# Access Compliance Report

## Public Rights-of-Way

### (Curb Ramps)

Intersection ID: 9942	Main Street: ANDRILL_TR	Cross Street: PATTON_AV	Location: SW
ADA ID: 28786AEB53BD	Ramp Type: Perp	Initial Pass/Fail: Fail	Overall Compliance: No
Codes/Mitigation Info/Possible Solution		Field Measurements/Component Compliance	
Severity Score: 21.25

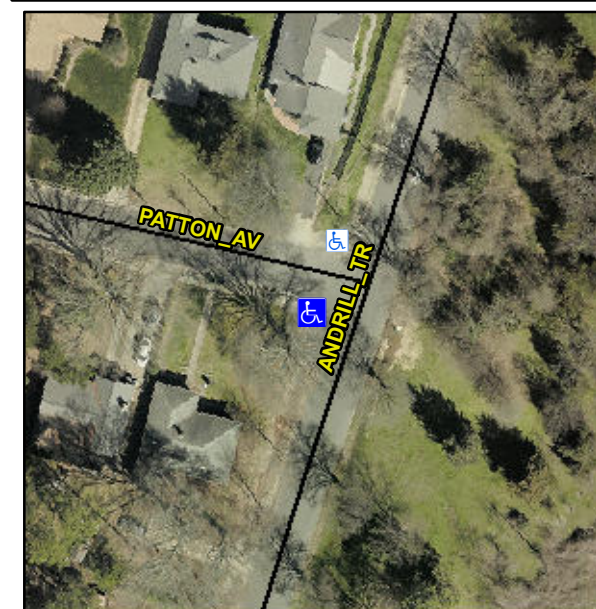
**Not Found, R304.5.1, R304.5.3**

Compliance	Description	Data	Compliance	Description	Data
N/A	Ramp Length (in)	72.0	Yes	Ramp Slope (%)	7.6
No	Ramp Width (in)	46.5	No	Ramp XSlope (%)	5.8
N/A	Flare Type LT	N/A	N/A	Flare Type RT	N/A
N/A	Flare Slope LT (%)	N/A	N/A	Flare Slope RT (%)	N/A
N/A	Flare Traversable LT?	N/A	N/A	Flare Traversable RT?	N/A
N/A	Landing Length (in)	N/A	N/A	DWS Provided?	N/A
N/A	Landing Width (in)	N/A	N/A	DWS Contrast?	N/A
N/A	Landing Slope (%)	N/A	N/A	DWS Length (in)	N/A
N/A	Landing X Slope (%)	N/A	N/A	DWS Full Width?	N/A
N/A	Landing Curb? (Y/N)	N/A	N/A	DWS Offset (in)	N/A
N/A	Shared Landing?	N/A			
N/A	Gutter Ponding?	N/A	N/A	Gutter Slope (%)	N/A
N/A	Gutter Lip Ht (in)	N/A	N/A	Gutter X Slope (%)	N/A
N/A	Painted X Walk1?	No	N/A	Painted X Walk2?	N/A
	X Walk 1 Direction	To NE		X Walk 2 Direction	N/A
N/A	X Walk 1 Width (in)	N/A	N/A	X Walk 2 Width (in)	N/A
	X Walk 1 Slope (%)	1.4		X Walk 2 Slope (%)	N/A
	X Walk 1 X Slope (%)	2.5		X Walk 2 X Slope (%)	N/A

**Remove & Replace Entire Ramp.**
